UNITED STATES PATENT AND TRADEMARK OFFICE

Office Action Summary

This is a second office action for serial number 10/053752, entitled Drywall Butt Joint System, filed on January 22, 2002.

FIG. 1

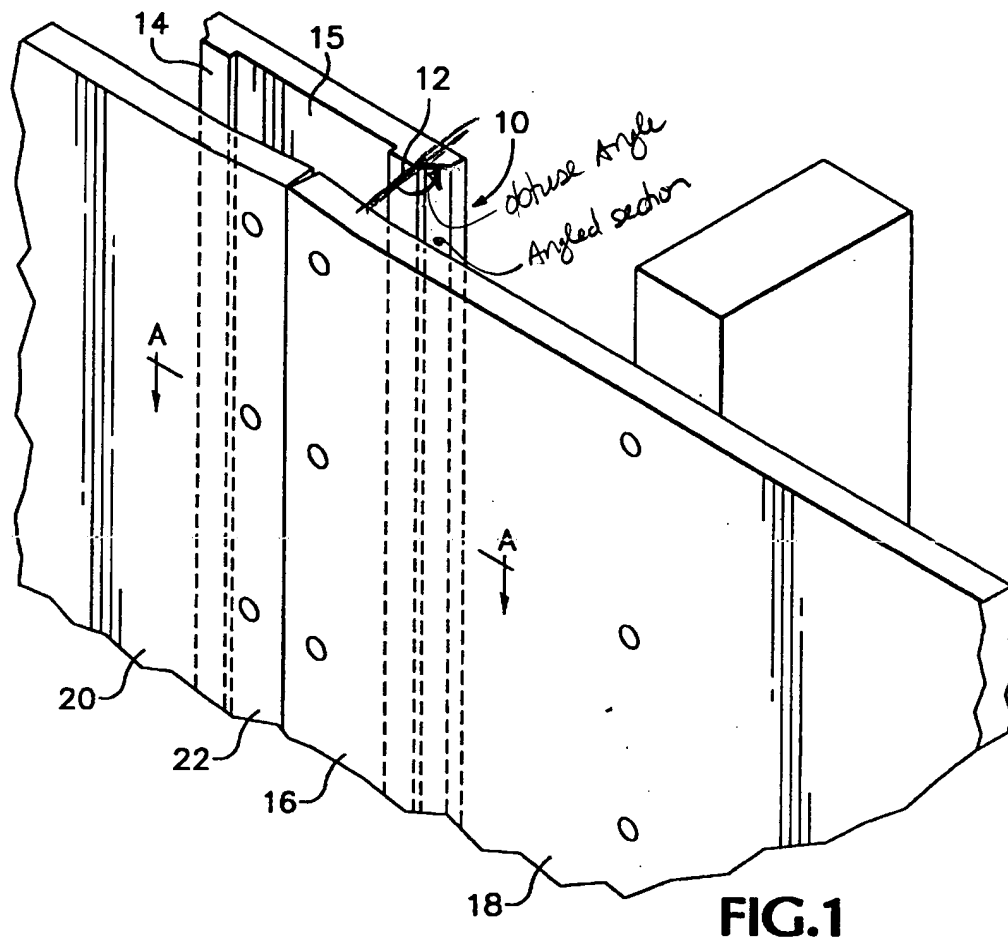
Klamer discloses the claimed invention a drywall butt joint system (10 – figure 1) comprising a middle section (15) comprised of an elongate structure having an inner surface (where 15 points to) and an outer surface (see attached figure 1), wherein the inner surface is positioned in opposition to the drywall sheets (18, 20), first and second angled sections (see attached figure 1) extending from opposing edges of the middle section (by 12 and 14) at an obtuse angle (see attached figure 1) with respect to the inner surface (where 15 points to), first and second sections (12, 14) extending from the angled sections respectively substantially parallel to the middle section (figure 1); the middle section (where 15 points to) has a substantially rectangular structure (figure 1);

and, the obtuse angle is greater than 120 degrees (shown to be greater than 180 degrees in the attached figure 1).

In regards to applicants argument that Klamer does not disclose all of the elements of claim 1, in regards to the examiners interpretation of figure 1, showing an angle of greater than 180 degrees, the examiner recognizes the argument, and the examiner asks the applicant to please review the newly submitted figure 1 of Klamer for better clarity of where the examiner was interpreting the angle to come from, parts 12 and 14 of figure 1, down to what is interpreted to be the angled sections as shown on the attached figure.
